## 7 INSTRUMENTATION AND CONTROLS

This chapter presents the U.S. Nuclear Regulatory Commission (NRC or Commission) staff's (herein after referred to as the staff) review of the instrumentation and controls (I&C) for the NuScale Power, LLC (NuScale), small modular reactor (SMR) nuclear power reactor design certification application. This is part of the design certification review conducted by the NRC staff under Title 10 of the *Code of Federal Regulations* (10 CFR) Part 52, "Licenses, Certifications, and Approvals for Nuclear Power Plants." The description of the I&C systems includes the overall design bases, system classifications, functional requirements<sup>1</sup>, and system architecture, which encompasses all I&C systems and components (i.e., hardware, software, firmware, and other forms of complex logic) and areas such as software tools and equipment that are used for the I&C design or are connected to the I&C systems or components for testing.

**Figure 7.2.7-1: Setpoint relationships during surveillance testing and calibration<sup>4</sup>**

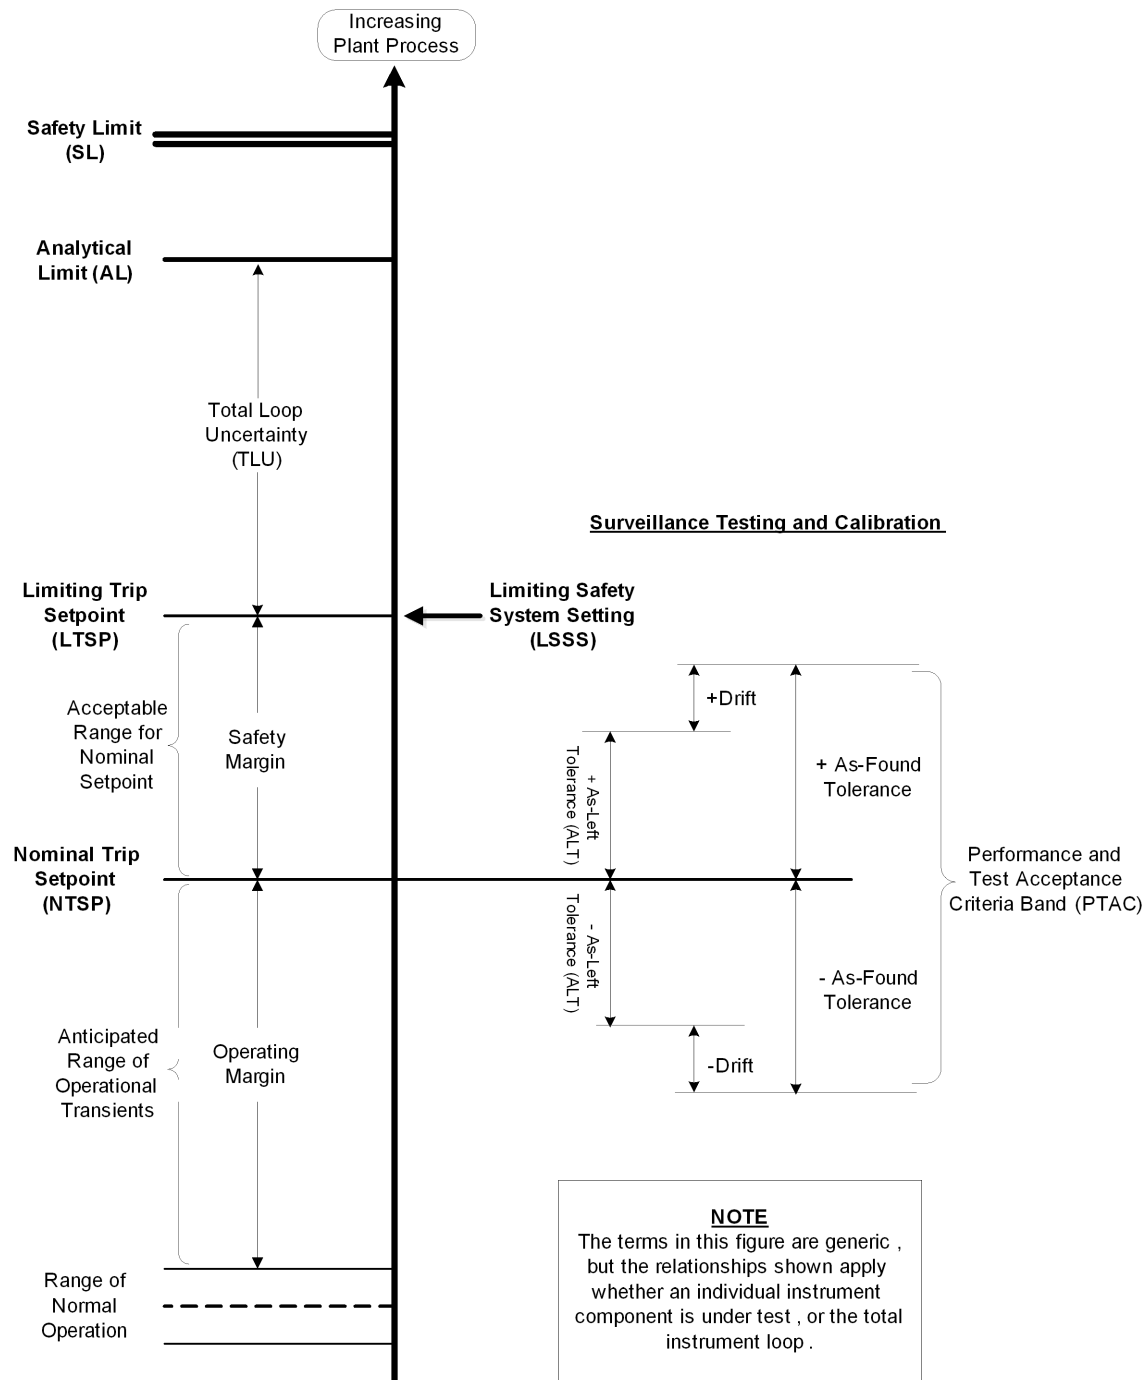
This figure is intended to provide relative position and not to imply direction. Sections 4.1.3 and 4.1.4 in TeR-0616-49121 define LTSP as an LSSS and also define NTSP as the desired value of the measured variable at which an actuation occurs. The calculation of the LTSP value is given in TeR-0616-49121, Section 4.2, Equation 4-1, as  $LTSP = AL \pm TLU$ , where TLU is the total channel uncertainty.
